GROUP ELE	MODEL 2015-2017MY Sedona (YP) w/PSD
	NUMBER 233	DATE March 2020
TECHNICAL SERVICE BULLETIN		
SUBJECT: POWER SLIDING DOOR (PSD) OPERATION INSPECTION AND REPAIR

This bulletin provides information regarding the replacement of certain Power Sliding Door (PSD) system parts associated with the 'Warranty Extension Program' (WTY019) on some 2015-2017MY Sedona (YP) vehicles produced from July 21, 2014 through April 4, 2017. The power sliding door may not completely latch upon closing in auto-mode. If this occurs, the open-door indicators such as activation of the chimes and illumination of the dashboard telltales and/or dome lights will occur. Inspect and diagnose the power sliding door function to identify the part requiring replacement.

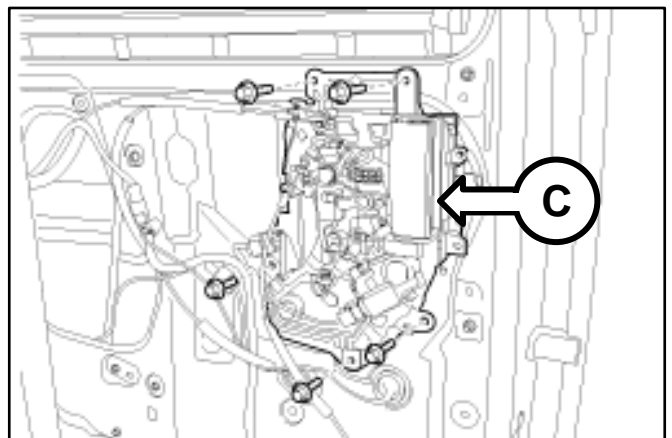
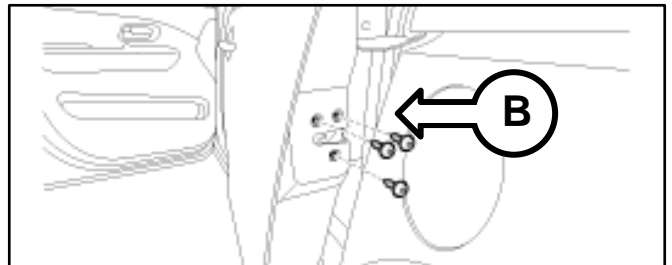
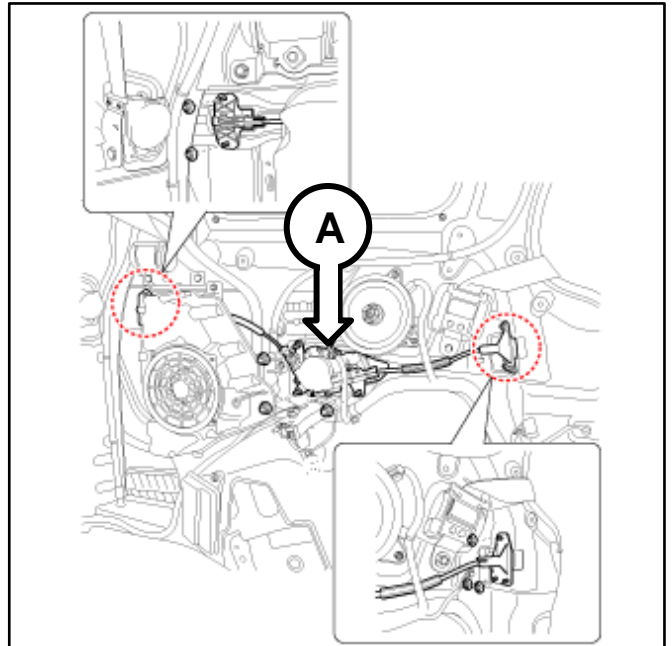
Replace the Power Sliding Door (PSD) Drive Unit/Motor (A) by referring to the “Body Electrical System → Power Sliding Door System → Power Sliding Door Drive Unit → Repair procedures” chapter in the applicable Shop Manual on KGIS.

- 2b. Replace the Rear Door Latch assembly (B) or PSD Remote Controller (C) as needed.

3. Replace the rear door latch assembly (B) by referring to the “Body (Interior Exterior) → Exterior → Rear Door → Rear Door Latch → Repair procedures” chapter in the applicable Shop Manual on KGIS.

Replace the PSD remote controller (C) by referring to the “Body Electrical System → Power Sliding Door System → Rear Door Remote Controller → Repair procedures” chapter in the applicable Shop Manual on KGIS.
